Display

Date: **July 24, 2000**

Model: **BVM-D14H1E, BVM-D14H1U  
 BVM-D14H5E, BVM-D14H5U**

Subject: **NOISE AT LEFT SIDE OF PICTURE  
 WHEN FEEDING SDI SIGNAL**

**Figure 1**

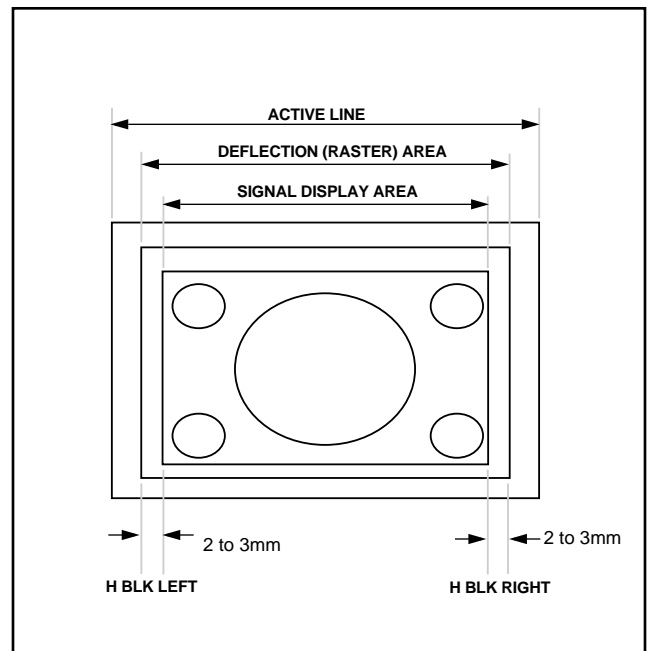
Noise may appear at the left side of the picture when inputting an SDI signal. To correct the symptom, perform the following modification procedure.

1. Input a 480/60i monoscope (or cross hatch) signal.  
**NOTE:** Make sure signal is composite or component. DO NOT input an SDI signal.
2. Set UNDERSCAN to ON.
3. Increase brightness by adjusting BRIGHT control until blanking is visible on monitor.
4. From MAINTENANCE menu, choose DEFLECTION menu.
5. Adjust H BLK RIGHT as shown in Figure 1.
6. Adjust H BLK LEFT.
7. Input 575/50i monoscope (or cross hatch) signal.
8. Repeat steps 2 through 6.
